Superfund Five-Year Review Report

Pickettville Road Landfill Jacksonville, Duval County, Florida

Prepared for
U.S. Environmental Protection Agency, Region IV
September 1999

Photograph #7

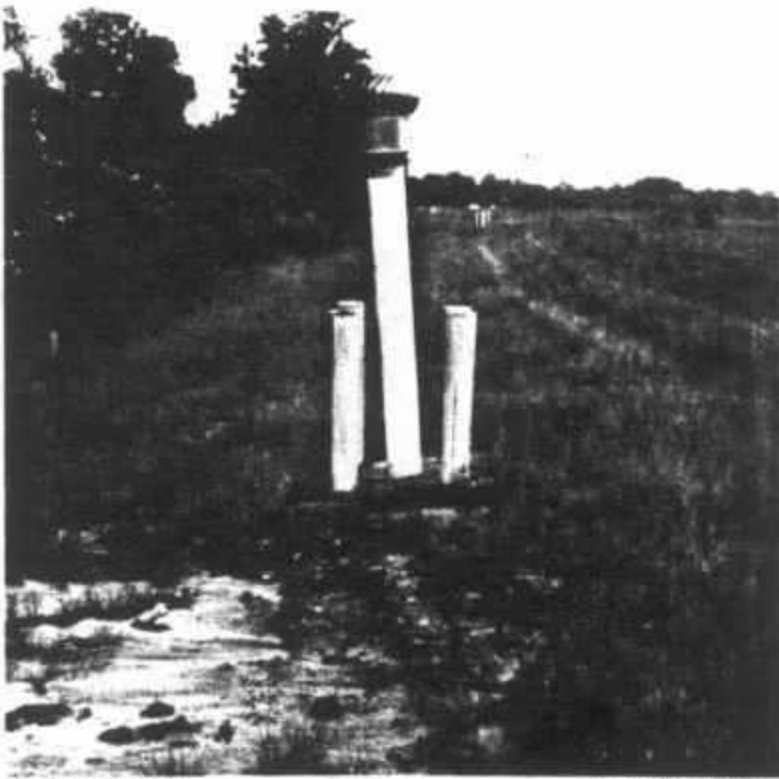
Description: View looking northwest toward center of landfill from Pond #2. Note the two rows of silt fencing which control erosion.

Photograph #8

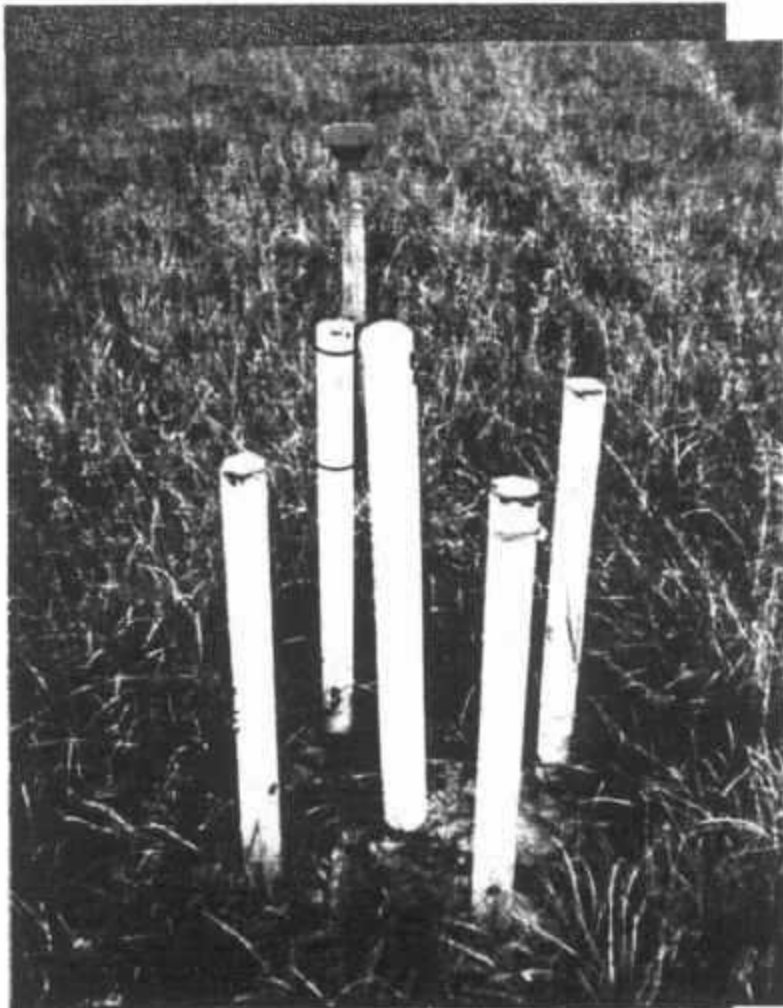
D. Several areas of sagging or collapsed silt fencing were observed.

Description: Collapsed silt fence in an area of localized erosion and ponding of water.

D. Repair or remove damaged silt fencing.
